General Bid Bulletin No. 8
11 October 2021

METRO MANILA SUBWAY PROJECT PHASE I

**PACKAGE CP103:
TWO UNDERGROUND STATIONS (ANONAS AND KATIPUNAN)
AND TUNNELS
(IFB No: 21-035-6)**

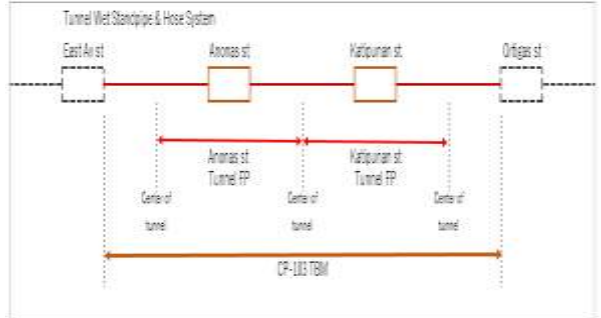
20.	Appendix 1	The Bidder understands the Electrical and	Bidder understanding is not correct as per technical

Metro Manila Subway Project Phase 1 PACKAGE CP103 (Anonas and Katipunan)			
ITEM NO.	REFERENCE/CLAUSE/SECTION	QUERIES	RESPONSE
	App 1-5 (3) Electrical and Mechanical (E&M) Works a) Electrical, Mechanical, and Plumbing System. Design and manufacture, installation, testing and commissioning of the E&M station and E&M tunnel shall comprise, but not be limited to, the following:..	Mechanical design is not the scope of the bidder and bidder shall follow the Employer's Drawings. Kindly confirm.	specification general requirement section 101.1.1.1 (design principle). By the said section, the scope of the contractor is not only limited to following the employer's drawings.

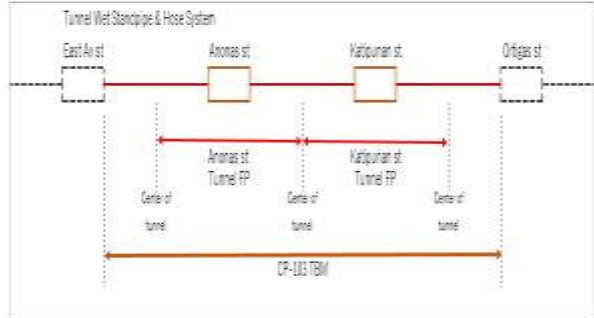
21.	App 8-4 Appendix 8 1. BIM Employer's Information Requirement	It is not clear on what is the Main purpose of BIM that will serve as desired result of the project. The Bidder would like to request the Employer to provide detail purpose of this requirements.	The Client have mandated the use of Building Information Management (BIM) throughout the construction, and operational stages of the project to fully utilize the potential for significant cost savings. The Metro Manila Subway Project (MMSp) provides an opportunity for the Client to establish and implement a robust working procedure for delivering a coordinated BIM model. The main objective of this BIM EIR are: <ul style="list-style-type: none"> • To establish a collaborative design using a common data environment (CDE) with all design discipline and stakeholders throughout the entire project lifecycle. • To standardize the production process and ensure all deliverables (2D, 3D drawings, BIM models and data schedules) are produced and issued in a uniform manner to the specified Engineer's CAD Manual, BIM standard / Approved issued BIM documents, • To define the structure of potential and

Metro Manila Subway Project Phase 1 PACKAGE CP103 (Anonas and Katipunan)			
ITEM NO.	REFERENCE/CLAUSE/SECTION	QUERIES	RESPONSE
			<p>proposed data embedded within digital BIM models such as for further use in future operations and maintenance,</p> <ul style="list-style-type: none"> • To eliminate waste by creating a virtual building processes in which the design, construction, performance, and operations can be visualized and stimulated, thus leading to potential cost saving in rework, coordination, clash mitigation and longer-term benefits within the post construction operations phase yet to be fully defined or established • Provide an open source as-built BIM model, which can be used by the Client to operate and maintain the line wide project. <p>The purpose of this Building Information Modelling (BIM) Employer Information Requirement (EIR) is to define the minimum information requirements for BIM use to be achieved by the Contractor in the Project to achieve the Client's overall BIM objective.</p> <p>This document will outline the objectives of the BIM implementation for the MMSP line; Level of Development (LOD) to achieve BIM modelling in construction; as-built and handing over phases, exchange of information, and collaborative design process as a requirement of the project.</p> <p>The BIM process shall be implemented for the whole of Contract phase for modelling, visualization, clash detection, CSD/SEM, simulation for Engineering study, coordination, documentation, creation of As-</p>

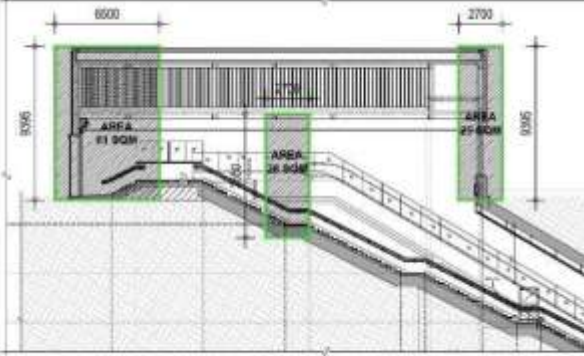
68.	Page No. 501 Intumescent Paint TS 1047 METAL STRUCTURES Section 1047.2.2 Materials	Please confirm if the following supports require intumescent painting: a. TS 1030 - Braces for ceiling supports b. TS 1030 - hangers for lighting and signages and the like	No. Wall Detail Label at Vent Tower 02 is wrongly tagged. Correct one is noise barrier. Tag should refer to drawing STN-AR-A-AN-9241

Metro Manila Subway Project Phase 1 PACKAGE CP103 (Anonas and Katipunan)			
ITEM NO.	REFERENCE/CLAUSE/SECTION	QUERIES	RESPONSE
	14) Paint Item 1) 1) Steel frame members shall be fully applied with waterborne fire-protection intumescent paint system in accordance to the required fire resistance ratings.

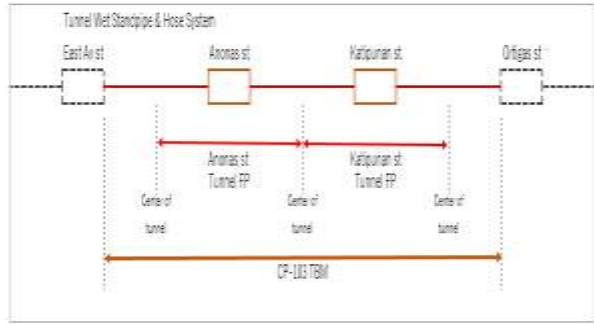
90.	4: Underground Structures EQC-4, 1.1.5 Method of Implementation of the Works, BF-45, Method of Implementation of the Works,	<p>In the Technical Specifications (TS), it is mentioned that Part 22: 2200 NATM and Related works is “Not Used”.</p> <p>The Bidder would like to clarify if the Bidder needs to provide Method Statement for the NATM Tunnel Work as required in the Evaluation and Qualification Criteria (EQC);</p>	Please refer to "Standard Specification for Tunneling 2016: Mountain Tunneling JSCE"

Metro Manila Subway Project Phase 1 PACKAGE CP103 (Anonas and Katipunan)			
ITEM NO.	REFERENCE/CLAUSE/SECTION	QUERIES	RESPONSE
	<p>Page 192 Part 22: 2200 NATM and Related works (3) Tunnel Works; TBM Tunnel and NATM Tunnel,</p> <p>3.3 Tunnels Works; Open Cut and Cover Tunnel and NATM Tunnel for Construction of Station and TBM Tunnel for Tunnel between Stations,</p> <p>Part 22: 2200 NATM and Related works – “Not Used”</p>	<p>1.1.5 Method of Implementation of the Works, and Method of Implementation of the Works.</p>

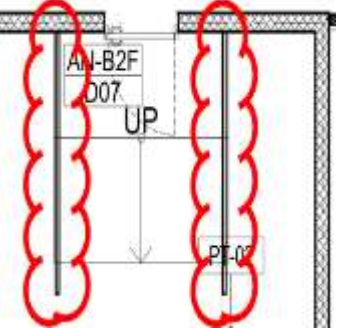
106.	<p>Architecture Drawings: Anonas Station,</p> <p>Architecture Drawings: Katipunan Station STN-MEP-BMS-CWD-1002</p>	<p>First paragraph says BMS shall control to reset set point however, second paragraph says maintenance purposes only.</p> <p>The Bidder would like to clarify that BMS is require to control CPM, however, set point of CPM shall be able to change by CPM only to</p>	<p>1. Refer to the Technical Specification 1217.2.1 under sequence of operation. 2. The Bidder should refer to the related Technical Plans. 3. Basically, design stages define the ideal operations and needs of the client and/or designer;</p>

Metro Manila Subway Project Phase 1 PACKAGE CP103 (Anonas and Katipunan)			
ITEM NO.	REFERENCE/CLAUSE/SECTION	QUERIES	RESPONSE
	<p>Control & Monitoring Interface Diagram for Air Cooled Chiller INTEGRATION WITH BMS 1, THE BMS OPERATOR SHALL BE ABLE TO CONTROL THE CHILLER PLANT MANAGER THROUGH GATEWAY TO RESET THE CHILLED WATER SUPPLY TEMPERATURE SET POINT AND CURRENT LIMIT FOR EACH CHILLER.</p> <p>2, CONTROL OF THE CHILLER PLANT MANAGER THROUGH THE BMS WILL BE FOR MAINTENANCE PURPOSES ONLY. ALL AUTOMATIC CHILLER PLANT SEQUENCE WILL BE EXECUTED THROUGH THE CPM ONLY AND NOT BMS.</p>	<p>avoid unexpected issue.</p>	<p>Those meters are part of the bid documents and therefore it should be there to function its purpose.</p>

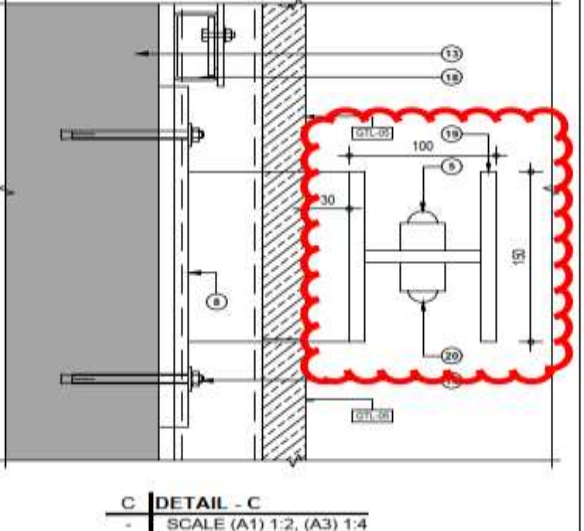
118.	14 / Arch_AN / STN-AR-A-AN-1302, 1303, 15 / Arch_KP / STN-KP-1302,1303	At STN-AR-A-AN-1302,1303 ANONAS STATION B2F LEVEL PLAN & STN-AR-A-KP-1302,1303 KATIPUNAN STATION B2F LEVEL PLAN, please provide the specification and detail of the clouded item beside Ramp.	The item in the cloud is not handrail. It is concrete corner cover at floor gap beside ramp. Updated drawing shall be provided.

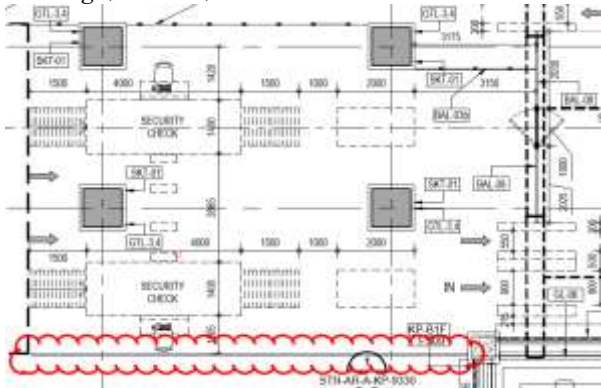
140.	14 / Arch_AN / STN-AR-A-AN-0501, 1203 Wall Finish	At B1F Emergency Staircase-01, Wall Finish differs as follows, STN-AR-A-AN-0501 ANONAS STATION FINISHING SCHEDULE (2 OF 2) ... Acrylic Emulsion Paint (PT-01) STN-AR-A-AN-1203 ANONAS STATION B1F LEVEL PLAN (PART 4 OF 6) ... 1200x600x10mm Ceramic Tile (CTL-01) + 1200x150x10mm Ceramic Tile (CTL-02)	Yes. Follow STN-AR-A-AN-0501. Ceramic Tile indicated in drawing STN-AR-A-AN-1203, refers to hallway only.

Metro Manila Subway Project Phase 1 PACKAGE CP103 (Anonas and Katipunan)			
ITEM NO.	REFERENCE/CLAUSE/SECTION	QUERIES	RESPONSE
		May we assume the one indicated at STN-AR-A-AN-0501 ANONAS STATION FINISHING SCHEDULE (2 OF 2), Acrylic Emulsion Paint (PT-01) to be correct?

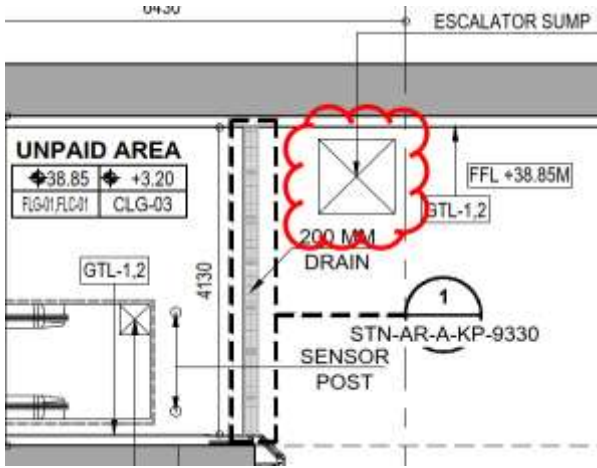
142.	14 / Arch_AN / STN-AR-A-AN-0601, 2103 to 2106 Smoke Screen (Curtain)	At B1F Unpaid Area, Paid Area, the layout of the Smoke Screen (Curtain) differs at STN-AR-A-AN-0601 ANONAS STATION B1F LEVEL PLAN LEGAL CHECK DRAWING and STN-AR-A-AN-2103 to 2106 ANONAS STATION B1F LEVEL RCP PLAN (PART-03 to 06 OF 06). May we consider STN-AR-A-AN-0601 ANONAS STATION B1F LEVEL PLAN LEGAL CHECK DRAWING correct?	Follow legal check drawing(STN-AR-A-AN-0601) indicated smoke screen.

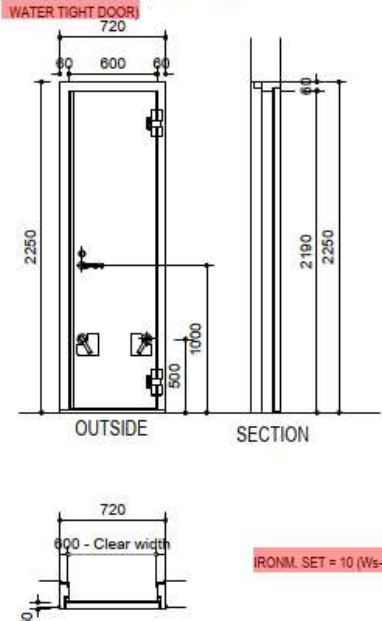
149.	15 / Arch_KP / STN-AR-A-KP-2501, 1601 Floor Finish	At B1F Emergency Staircase-01 and other Staircases, Floor Finish differs as follows, STN-AR-A-KP-2501 KATIPUNAN STATION B1F LEVEL PLAN FLOOR FINISHES (PART 2 OF 6)	Follow Concrete Trowel with Floor Hardener (FCF-02) at emergency staircases as indicated in STN-AR-A-KP-2501, Floor finishes plan.

Metro Manila Subway Project Phase 1 PACKAGE CP103 (Anonas and Katipunan)			
ITEM NO.	REFERENCE/CLAUSE/SECTION	QUERIES	RESPONSE
		<p>... Concrete Trowel with Floor Hardener (FCF-02) STN-AR-A-KP-1601 KATIPUNAN STATION CROSS SECTION D</p> <p>... Cinder Concrete Filled Floor with Trowel finished with Concrete Hardener (FCF-04)</p> <p>May we assume the one indicated at STN-AR-A-KP-2501 KATIPUNAN STATION B1F LEVEL PLAN FLOOR FINISHES (PART 2 OF 6), Concrete Trowel with Floor Hardener (FCF-02) to be correct?</p>

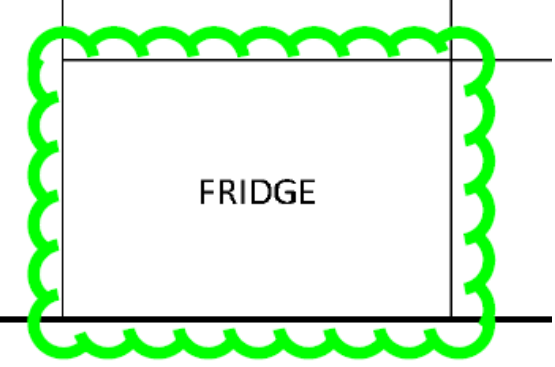
158.	15 / Arch_KP / STN-AR-A-KP-1704,1707,9210 Cat Ladder	At STN-AR-A-KP-1704,1707 Katipunan Station Long Section B, may we assume the Detail of Cat Ladders for VS, VE, and Relief Cutout at B1F & B2F to be STN-AR-A-KP-9210 Typical Details of Roof Access Hatch & Elevator Pit Ladder?	Follow ladder detail for the identified locations VS, VE and relief cuout as per drawing: TYPICAL DETAILS OF CAT LADDER DETAILS, STN-AR-A-KP-9220/9221

Metro Manila Subway Project Phase 1 PACKAGE CP103 (Anonas and Katipunan)			
ITEM NO.	REFERENCE/CLAUSE/SECTION	QUERIES	RESPONSE
159.	15 / Arch_KP / STN-AR-A-KP-6000,9840 Flood Barrier	<p>The existence of Flood Barrier (W=1400) at GF Entrance 1 Slope deffers as follows, STN-AR-A-KP-6000 Katipunan Station Entrance-1 Plans ... Existent STN-AR-A-KP-9840 Typical Details of Flood Barrier ... Non-existent May we consider STN-AR-A-KP-6000 Katipunan Station Entrance-1 Plans correct and consider the Flood Barrier to be Existent?</p>	<p>The slope shown at GF entrance flood barrier area is correct. The flood barrier is existent in both drawings referenced (STN-AR-A-KP-6000 Entrance 1 Plans and STN-AR-A-KP-9840 Typical Details of Flood Barrier.</p>

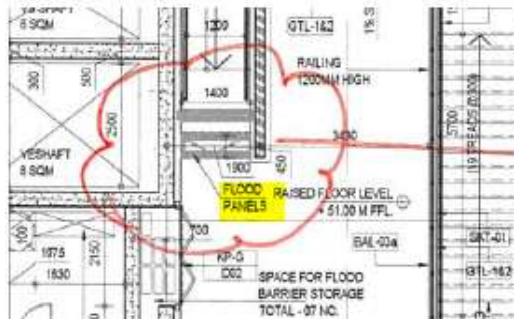
160.	14 / Arch_KP / STN-AR-A-KP-7007 Ironmongery Type	<p>At STN-AR-A-KP-7007 KATIPUNAN STATION DOOR AND IRONMONGERY SCHEDULE (1 OF 4), Ironmongery Type of Door KP-GF D04 is Type 10. Since its Door Type is Type T1A(Watertight Door) as shown below, may we read Type 10 as Type 10(Ws-3)?</p>	<p>STN-AR-A-KP-7007 DOOR AND IRONMONGERY SCHEDULE (1 OF 4) Ironmongery Type of Door KP-GF D04 Type 10 is incorrect. Door Type T1A(Watertight Door) Type 10(Ws-3) is</p>

Metro Manila Subway Project Phase 1 PACKAGE CP103 (Anonas and Katipunan)			
ITEM NO.	REFERENCE/CLAUSE/SECTION	QUERIES	RESPONSE
		<p>DOOR TYPE T1A CLEAR W=600 , H=2190(1.5 HRS FIRE RATED, WATER TIGHT DOOR)</p> 	<p>correct.</p> <p>Follow drawing DOOR AND IRONMONGERY SET, STN-AR-A-KP-7011 - Door Type T1A</p>
161.	14 / Arch_AN / STN-AR-A-AN-0500,9500 15 / Arch_KP / STN-AR-A-KP-0500, 9500,9501 Wall Finish	<p>Regarding the wall finish PB-01 Phenolic Board, the thickness differs as follows, STN-AR-A-AN-0500 ANONAS STATION FINISHING SCHEDULE ... t=12mm</p> <p>STN-AR-A-AN-9500,9501 TYPICAL DETAILS OF TOILET CUBICLE PARTITION</p>	<p>Technical specification prevails, Refer to TS 1816.2.1 (2) (a) . The toilet cubicle partition thickness is 18mm.</p>
